STAGE 2 LRT PROGRAM

New Bayshore to Moodie LRT Extension EPR and Proposed changes to Stage 2 LRT existing EPRs

- Confederation East Line Extension EPR
 - *Existing Trim Park and Ride Expansion*
- Confederation West Line Extension EPR
 - *Goldenrod Bridge Addition of Left Turn Lane*
 - *Bayshore Bus Staging Area Modifications*
- Trillium Line Extension EPR
 - *Bowesville Station Alternative Alignment and Extension to Limebank*
 - *Ellwood Diamond Rail Crossing Grade Separation*
 - *Walkley Yard Maintenance Facility Location*
- Bayshore to Moodie LRT Extension EPR

Existing Trim Park and Ride Expansion

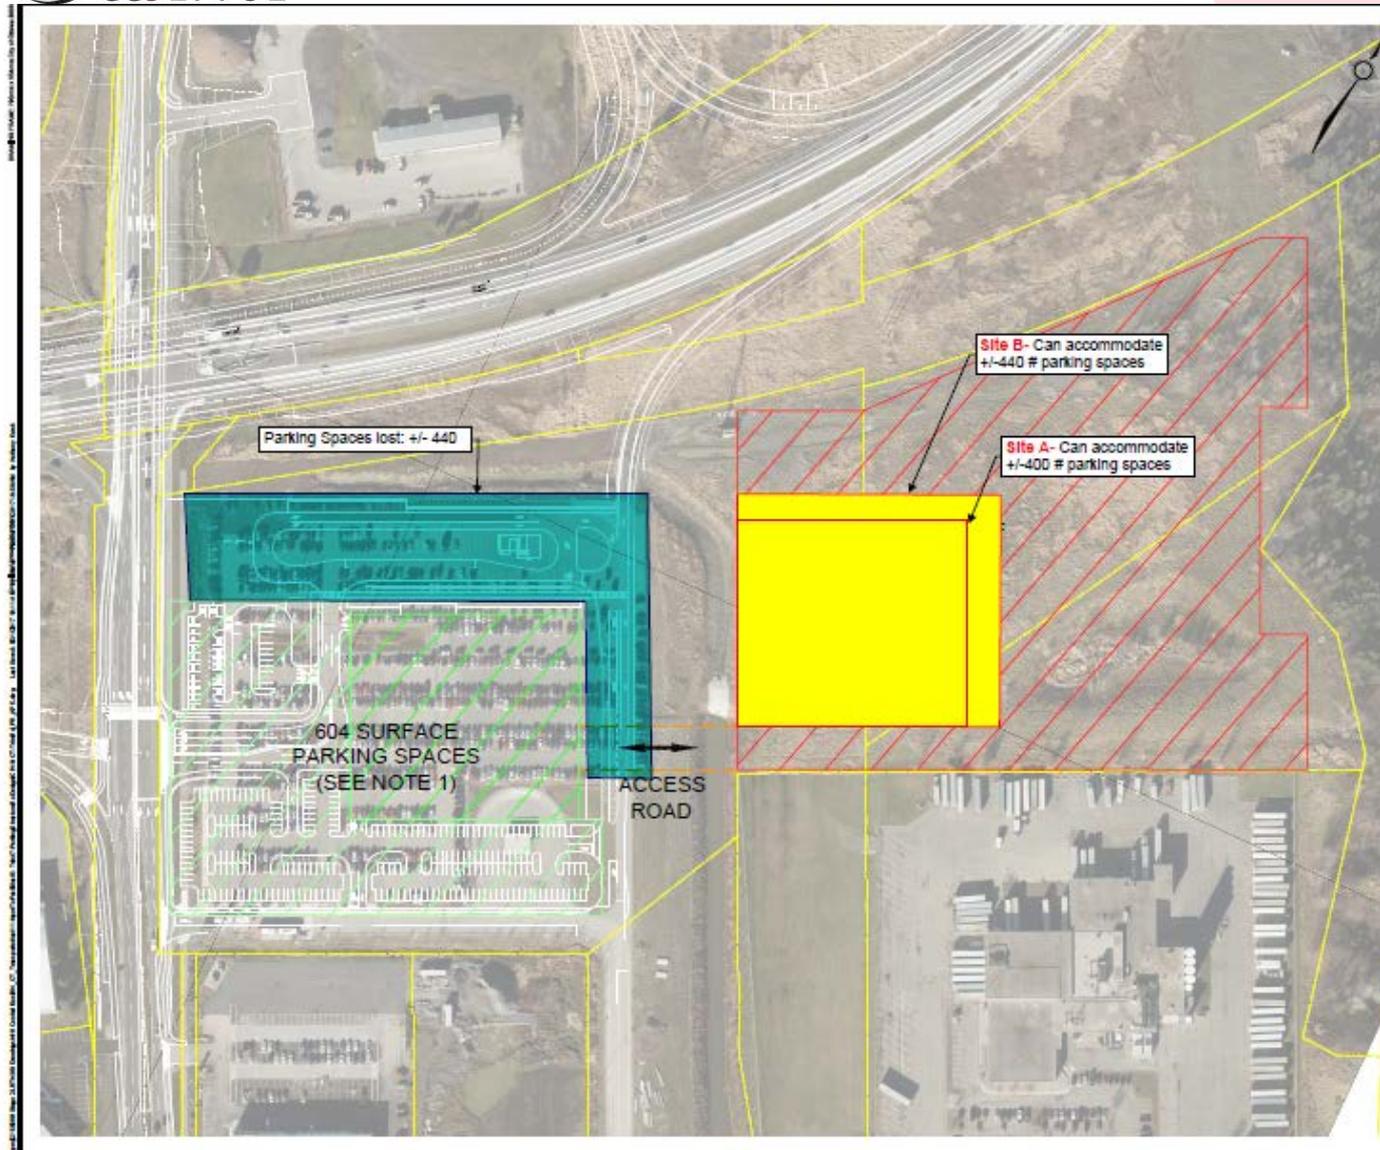
- Proposed change includes :
 - a new satellite surface parking site located to the east side of the existing SWM pond;
 - appropriate accesses from and to the main parking site;
 - new/modified stormwater management facilities; and
 - potential utilities relocations.

Change proposed is considered consistent and will be documented in a technical memo to be included in the project file

Confederation West Goldenrod Bridge Proposed Change

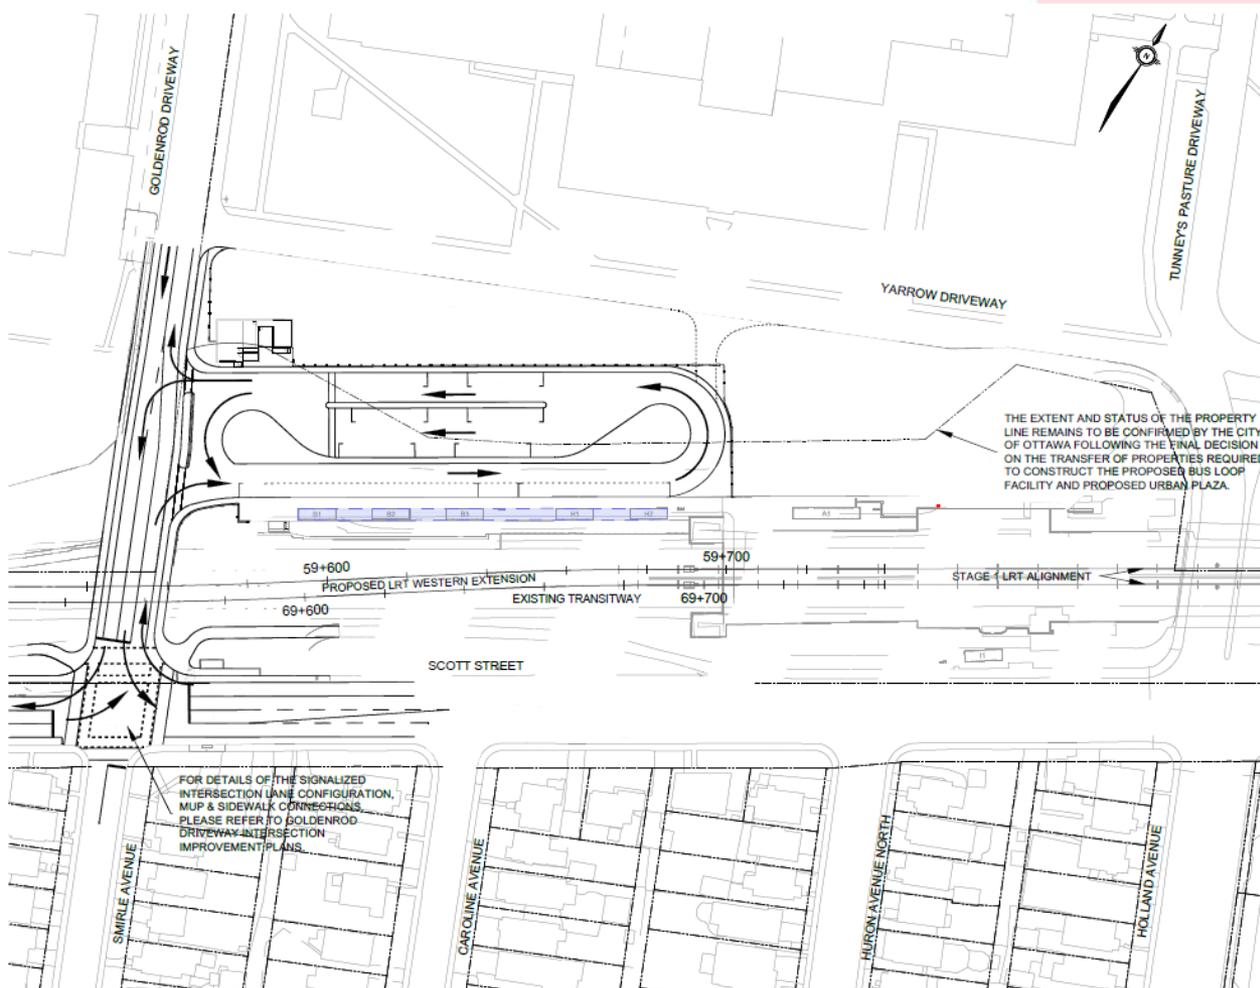
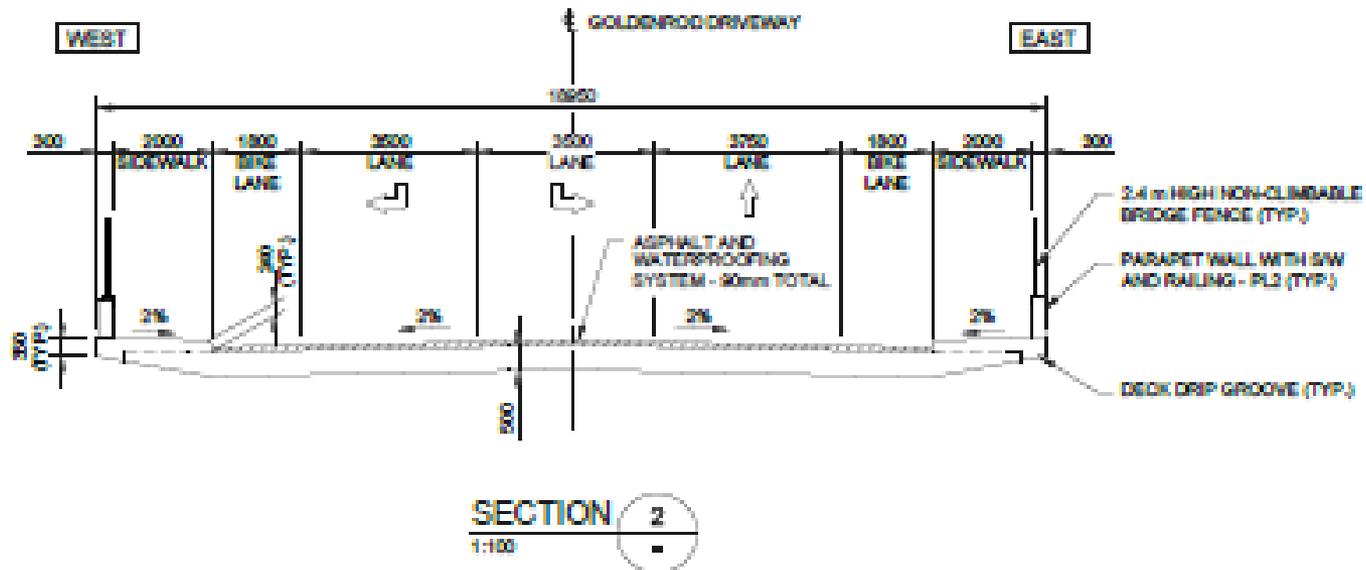
- Proposed change scope is the addition of a left turn auxiliary lane to ensure fluidity of traffic movement in and out of the redeveloped Tunney's Pasture complex.

Change proposed is considered consistent and will be documented in a technical memo to be included in the project file

Bayshore Bus Staging Area Proposed Changes

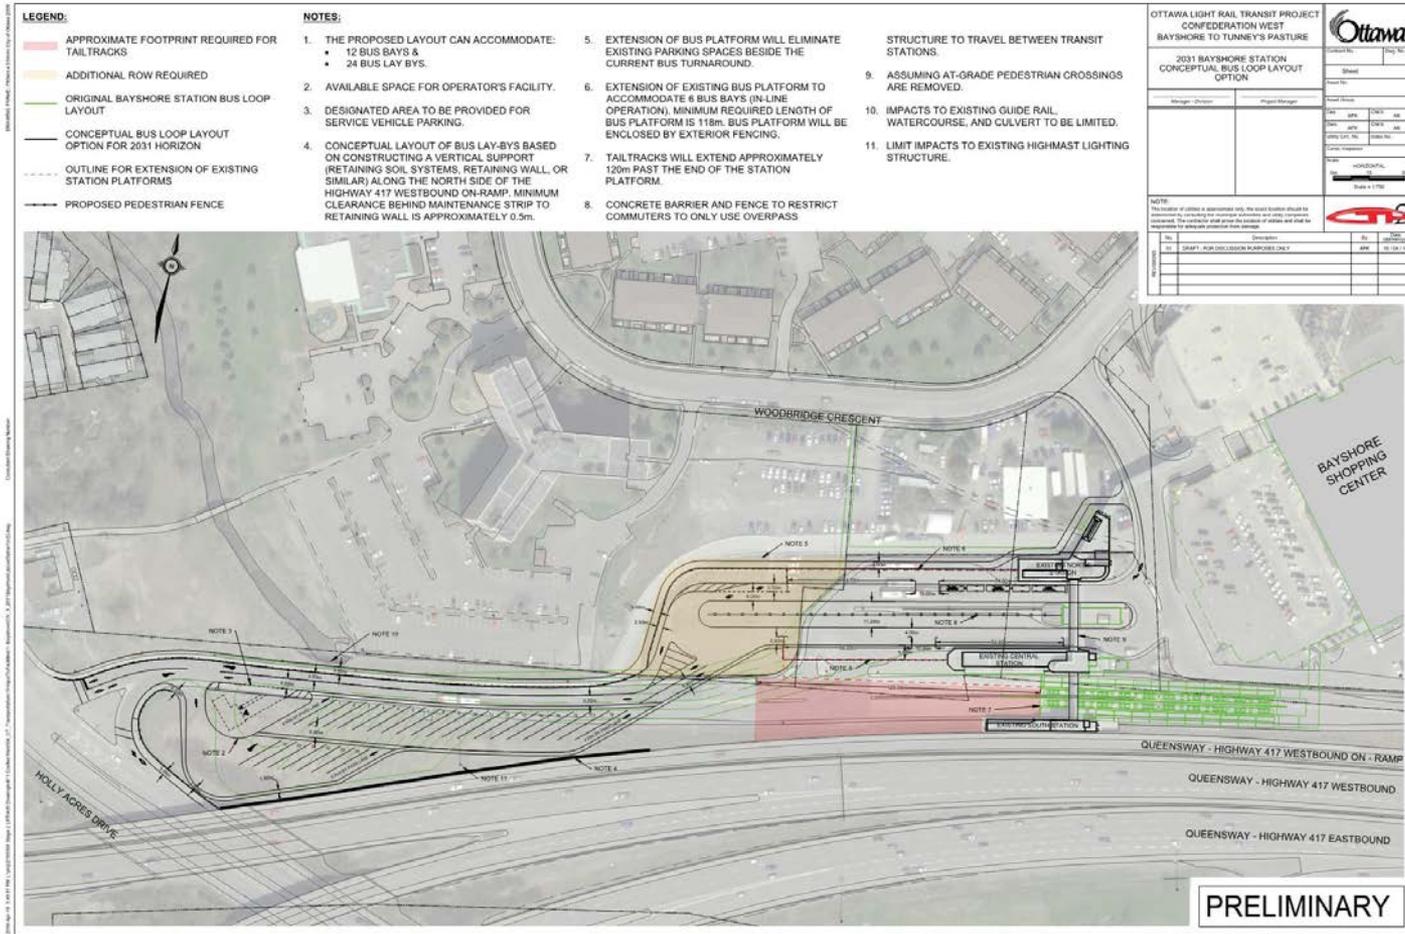
Preliminary engineering concept for Bayshore bus station and lay-by, includes the following:

- 12 bus bays
- 24 bus laybys
- Available space for operator's facility
- Designated area for service vehicle parking
- Vertical support (in the form of retaining soil systems, wall, or similar) along the north side of the Highway 417 westbound on-ramp
- Extension of bus platform westward, to accommodate 6 bus bays
- Extension of tail tracks approximately 120 metres past the end of the station platform
- Concrete barrier and fence to restrict commuters to use the overpass to travel between transit stations
- At-grade pedestrian crossings are removed between existing north and central stations
- Limited impact to existing guide rail, watercourse, and culvert

Change proposed is considered consistent and will be documented in a technical memo to be included in the project file

Walkley Yard Proposed Change

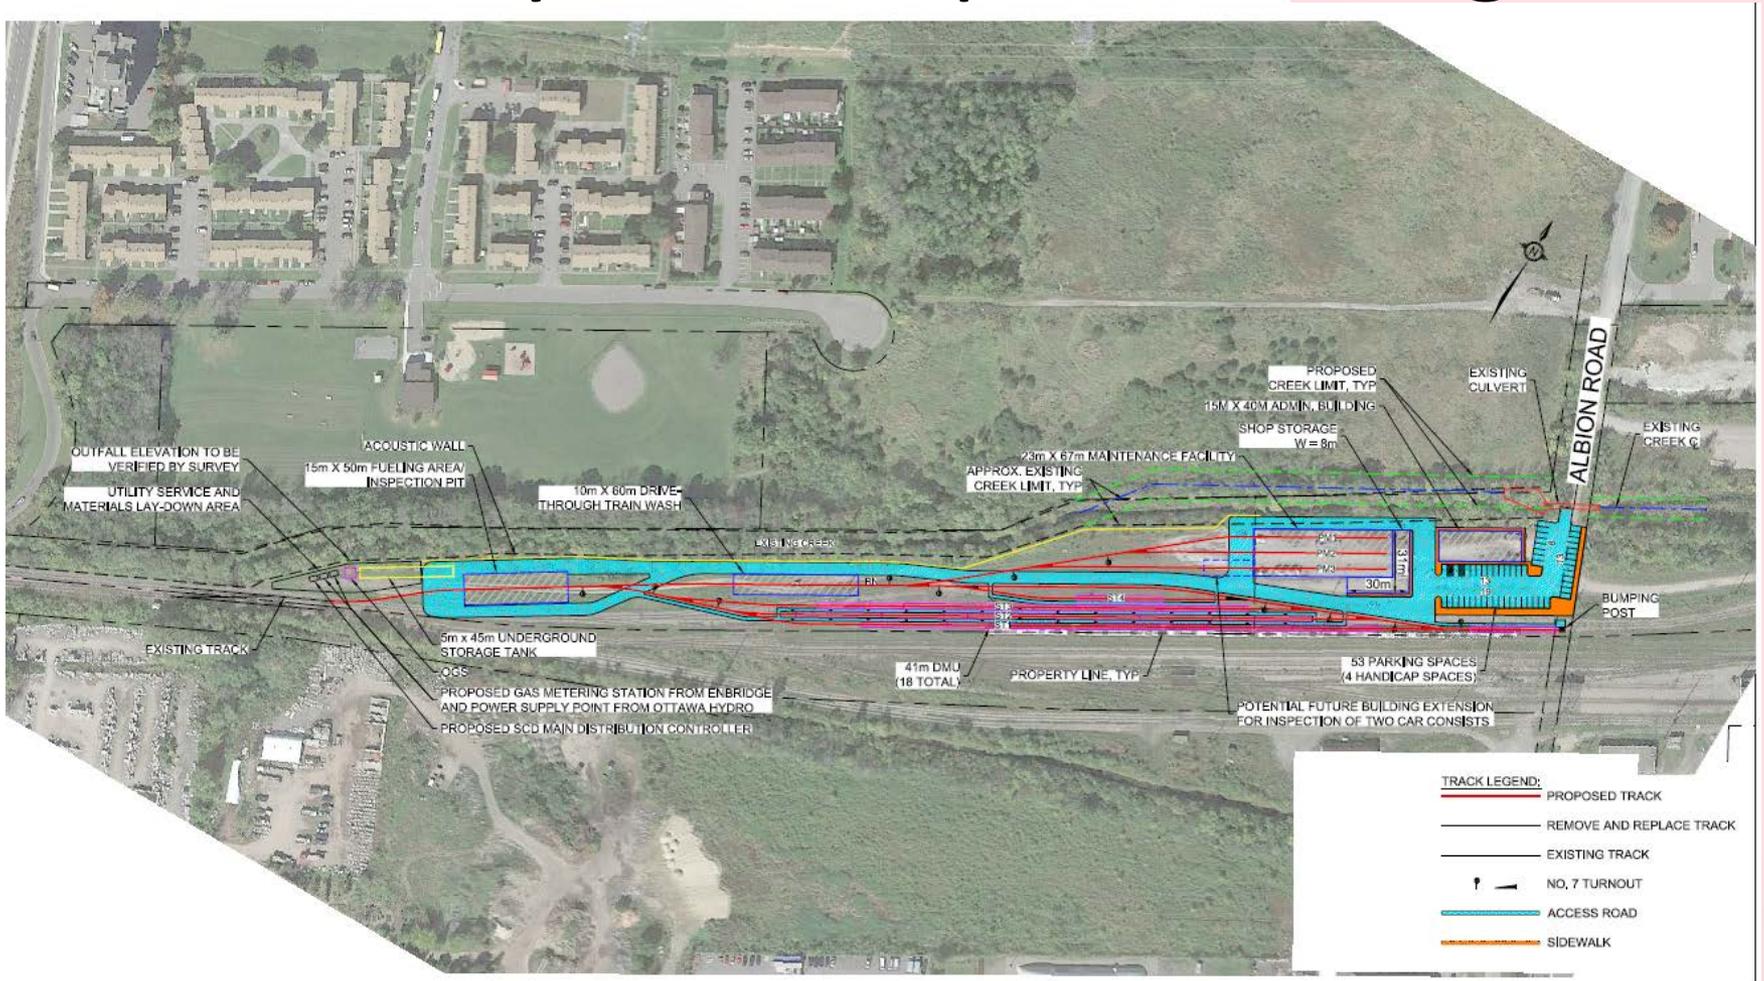
As part of the development of the Preliminary Engineering Reference Design, the Walkley Yard Site has been under review. Options for optimizing the site and reducing costs have been considered. The existing Walkley Yard is currently leased to the City from CP Rail. One of the options being considered is an alternative site adjacent to and west of the current Walkley site which is owned by the City.

Change proposed is considered not significant and will require preparation of an addendum report.
